Groundwater Review Summary Form

Application # G- 18405

TO: Water Rights Section Date 4/27/2017
 FROM: Groundwater Section Jen Woody/Joe Kemper
Reviewer's Name
 SUBJECT: Application G- 18405 Supersedes review of
Date of Review(s)

A. GENERAL INFORMATION: Applicant's Name: Matthew and Amy Roloff County: Washington

Figure 3. Water-Level Trends in Nearby Wells

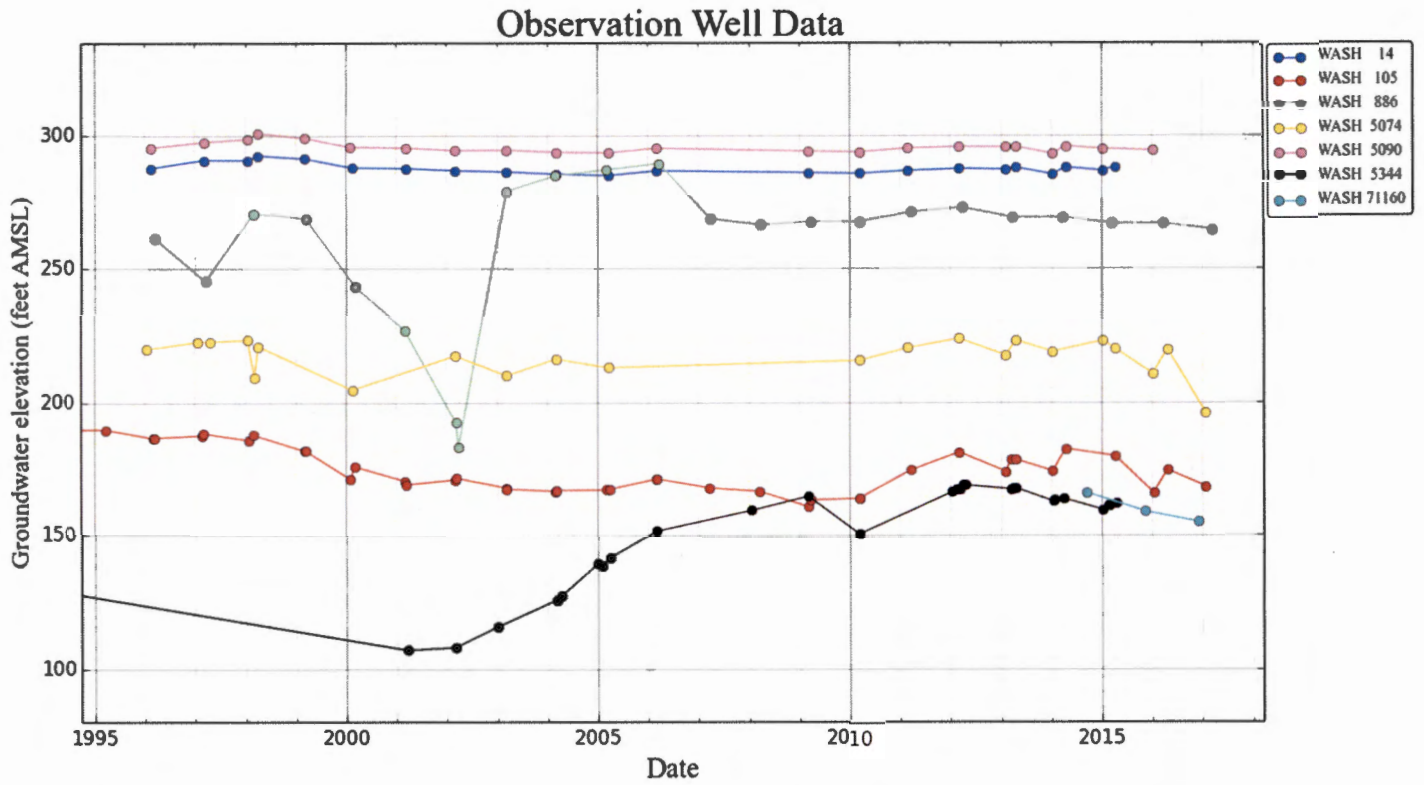
A survey of water levels in the vicinity show that shallow basalt wells have shallow water levels and deep basalt wells have deeper water levels (see Figures 2 & 3). These shallower basalt wells are located primarily in the uplands and do show relatively stable water levels. The proposed well construction would likely access the same water bearing zone. However, a survey of adjacent well logs of similar depths show that the proposed rate of 450 gpm from either well is an order of magnitude greater than mean well yields in the area. Median yield for wells for wells between 150 and 450 ft deep within T1N/R2W-S(1-12) and T2N/R2W-S(31-36) is 20.5 gpm (see Figure 4). At closer range, median yield for wells between 150 and 450 ft deep within T1N/R2W-S(3-4) is 30.0 gpm (see Figure 5). The proposed use is, therefore, not likely within the capacity of the resource.
